A Planning Application by
COMPLETE PLANT HIRE LIMITED

In respect of
**12 Southfields,
WELWYN GARDEN CITY**

Technical Note – Survey Summary

August 2021

Figure 2.3 Personal Injury Collision Data

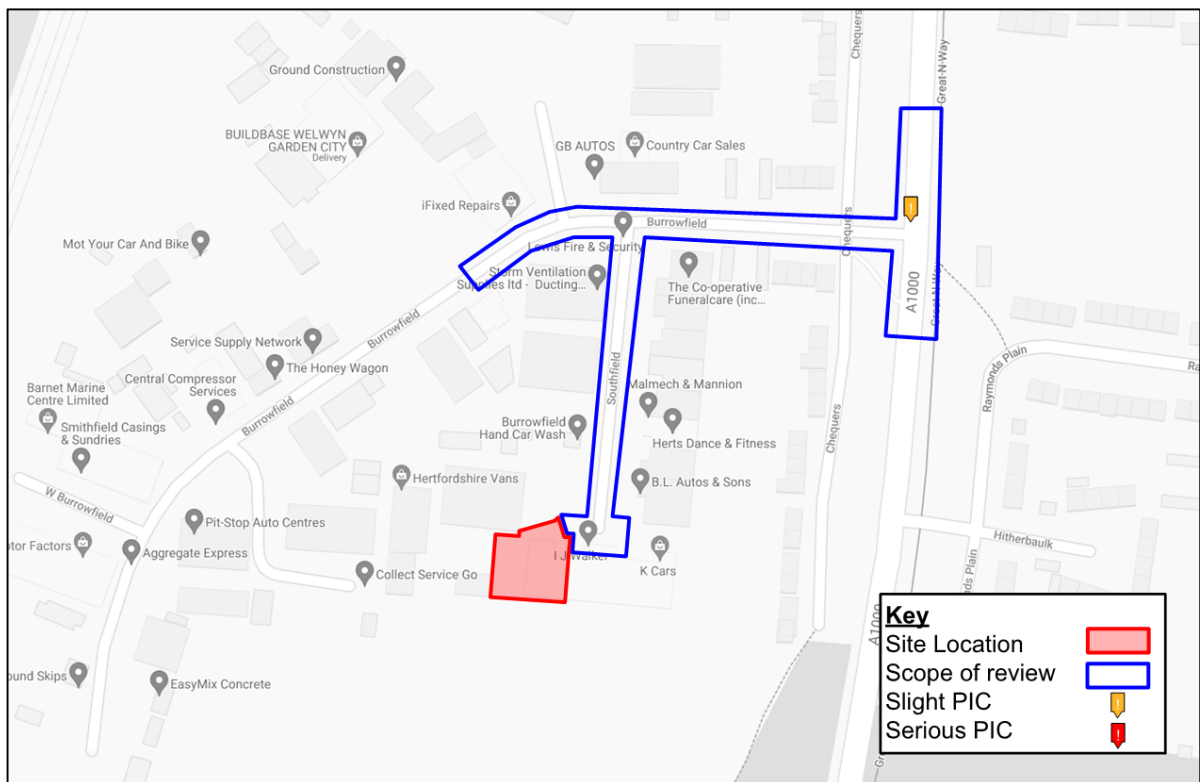
“Review of personal injury collisions on the local highway network over the most recently available five years of data.”

The Transport Technical Note has not included a review of personal injury collisions that have occurred on the local highway network over the most recently available five-year period of data. The Highway Authority request this is undertaken, and details of patterns/clusters of collisions must be provided.

- 2.17 Accordingly, a review of the personal injury collision (PIC) record for the local highway network has been undertaken, based on the most recent five years of data obtained from Crashmap. The data, summarised in **Figure 2.3**, shows that only one slight PIC has been recorded in the five year period between 2016–2020. As can be seen, this incident took place on the A1000 close to the junction with Burrowfield and at some remove from the site.

- 2.18 A single PIC within the last 5-year period does not indicate that there is any significant highway safety issue in the vicinity of the site. It is also the case that the current use of the site has been in operation for 5 years and it is understood that the PIC identified did not involve a vehicle associated with Complete Plant Hire Ltd.

SWEPT PATH ANALYSIS OF
 A 26t RIGID VEHICLE

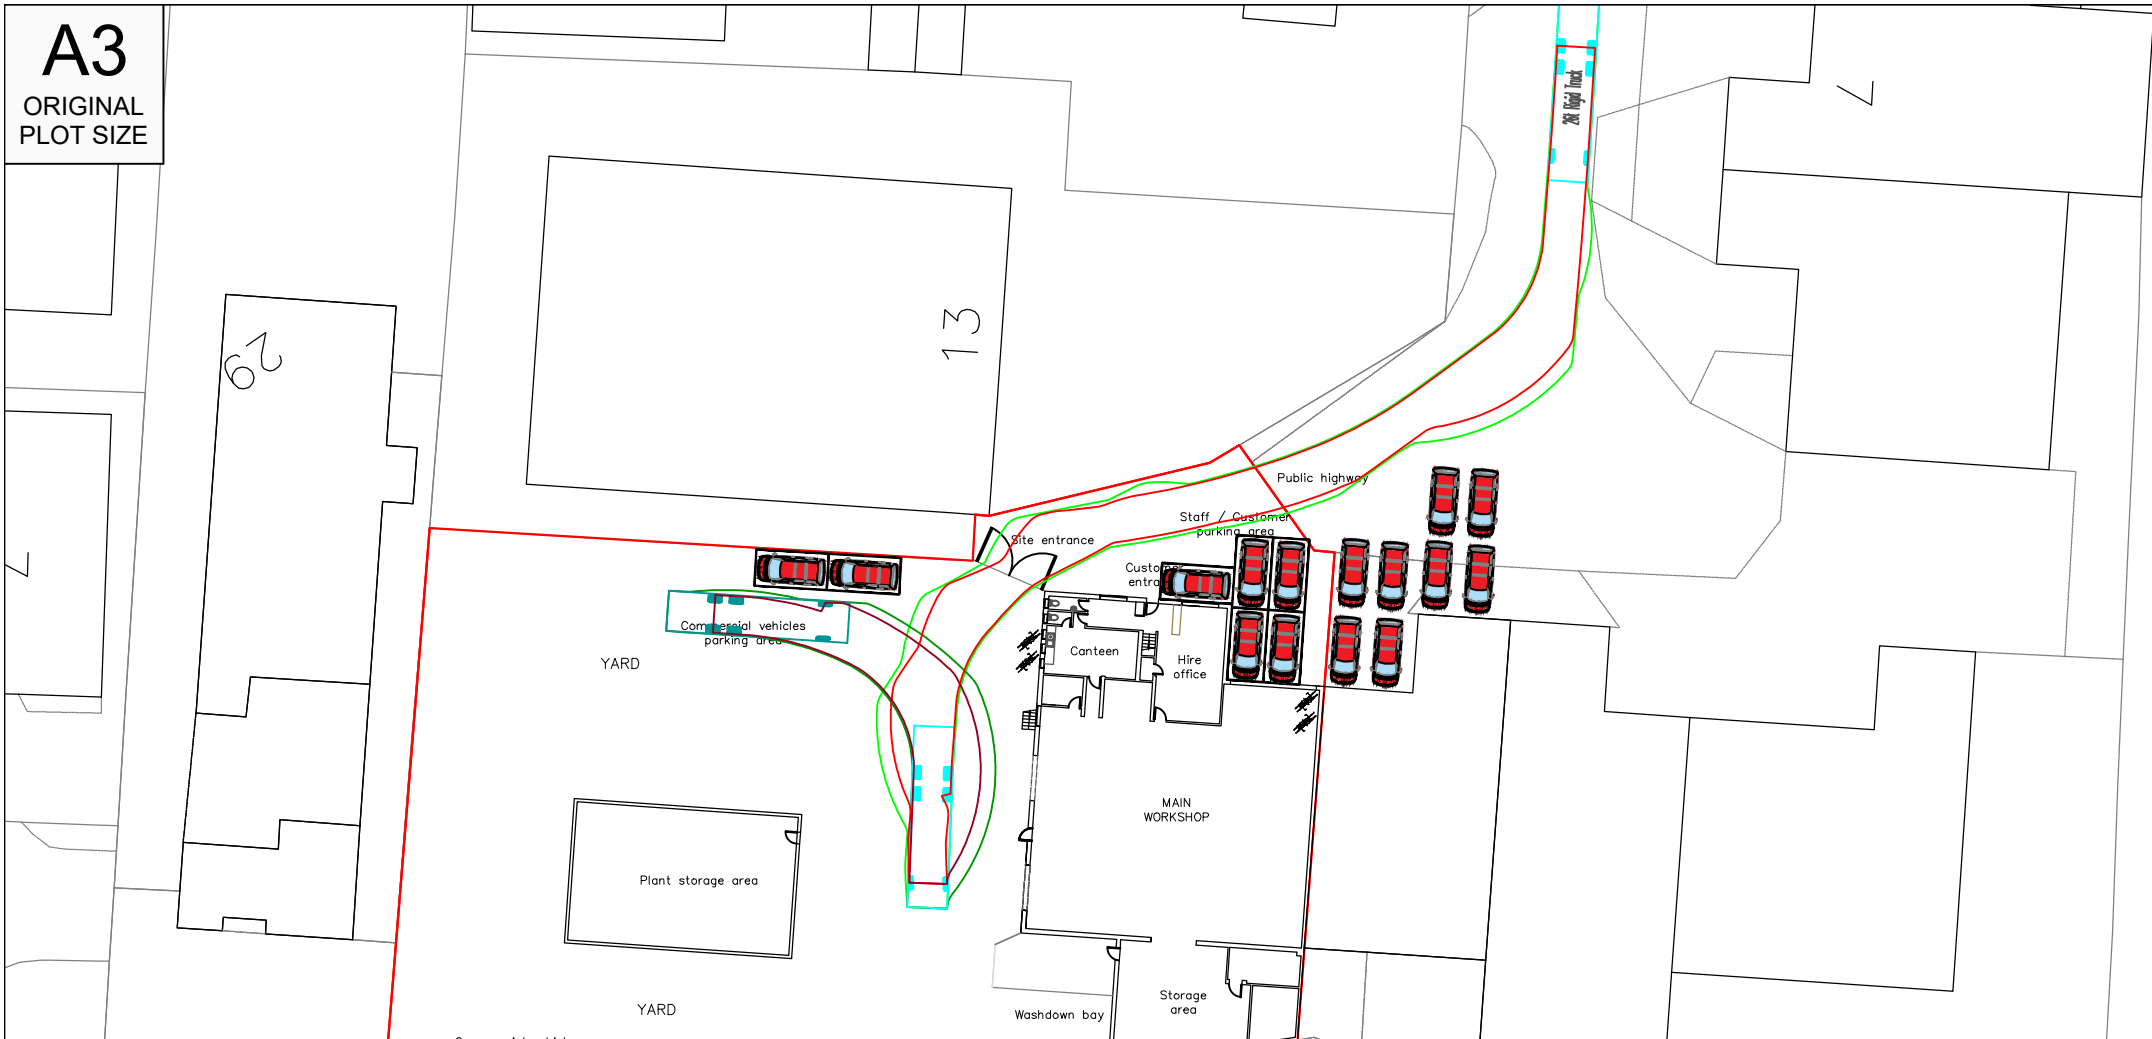
“The Highway Authority are concerned that the Transport Technical Note contained only limited details of the types of vehicle that access the site and therefore the swept path shown in Drawing No. SP01 may not representative of the largest vehicle that will commonly use the site (i.e. lengths of low loaders and articulated vehicles). Without these details there is a highway safety risk that large vehicles may reverse long distances on the public highway.”

The Highway Authority are concerned that the Transport Technical Note contained only limited details of the types of vehicle that access the site and therefore the swept path shown in Drawing No. SP01 may not be representative of the largest vehicle that will commonly use the site (i.e. lengths of low loaders and articulated vehicles). Without these details there is a highway safety risk that large vehicles may reverse long distances on the public highway.

- 3 x Box Vans - 6.5m x 2.1m;
- 1 x 26 tonne rigid trucks - 12m x 2.55m; and
- 2 x pick-up trucks - 6.6m x 2.1m.

2.10 A swept path analysis of a 26 tonne vehicle has been undertaken and is contained within **Appendix C**. As can be seen, the vehicle can enter and exit the site in forward gear. This manoeuvre can be seen in the CCTV survey.

EXISTING PARKING
PROVISION

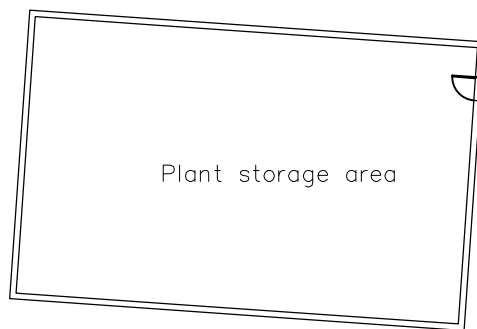
“There is also a concern that the details of formal on-site car parking arrangements have not been provided or shown on a plan. Therefore, the turning area of vehicles in the yard may be blocked by informal parking.”

There is also a concern that the details of formal on-site car parking arrangements have not been provided or shown on a plan. Therefore, the turning area of vehicles in the yard may be blocked by informal parking.

The applicant has provided no details of the number of on-site car parking spaces, nor details of cycle parking provision.

2.12 Notwithstanding that the video survey undertaken demonstrates that the all vehicles access and egress the site in forward gear, the majority of parking for the site occurs on the frontage in an informal tandem arrangement where necessary. Staff are able to move vehicles to ensure that access to the yard to the rear of the site is not restricted.

- 2.14 As shown, the parking associated with the site does not impact upon the access arrangement for the site itself, which is located at the end of a service stub from Southfields. Notwithstanding this, a plan has been prepared that shows the cycle and car parking used by the site, which is reproduced at **Appendix D**.
- 2.15 As can be seen, the site will provide a total of four cycle parking spaces, comprising spaces within the yard and two spaces within the building.
